PIC18F86J72/87J72 Silicon Errata and Data Sheet Clarification

The PIC18F86J72/87J72 devices that you have received conform functionally to the current Device Data Sheet (DS39979A) except for the anomalies described in this document.

The following typographic corrections and clarifications are to be noted for the latest version of the device data sheet (DS39979A).

FIGURE 2-3 FREQUENCY vs. ESR PERFORMANCE FOR SUGGESTED VCAP

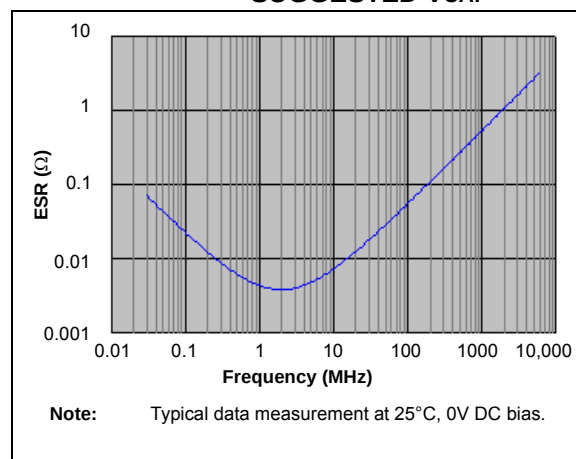
Section 2.4 Voltage Regulator Pins (ENVREG and VCAP/VDDCORE) has been replaced with a new and more detailed section. The entire text follows:

When the regulator is enabled, a low-ESR ($< 5\Omega$) capacitor is required on the VCAP/VDDCORE pin to stabilize the voltage regulator output voltage. The VCAP/VDDCORE pin must not be connected to VDD and must use a capacitor of 10 μF connected to ground. The type can be ceramic or tantalum. Suitable examples of capacitors are shown in Table 2-1. Capacitors with equivalent specifications can be used.

Designers may use Figure 2-3 to evaluate ESR equivalence of candidate devices.

FIGURE 2-4 DC BIAS VOLTAGE vs. CAPACITANCE CHARACTERISTICS

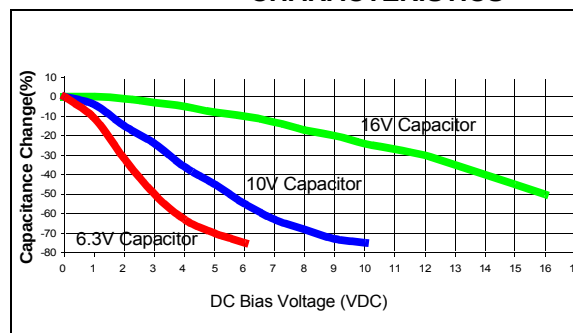
In addition to temperature tolerance, the effective capacitance of large value ceramic capacitors can vary substantially, based on the amount of DC voltage applied to the capacitor. This effect can be very significant, but is often overlooked or is not always documented.

A typical DC bias voltage vs. capacitance graph for 16V, 10V and 6.3V rated capacitors is shown in Figure 2-4.

When selecting a ceramic capacitor to be used with the internal voltage regulator, it is suggested to select a high-voltage rating, so that the operating voltage is a small percentage of the maximum rated capacitor voltage. For example, choose a ceramic capacitor rated at 16V for the 2.5V core voltage. Suggested capacitors are shown in Table 2-1.
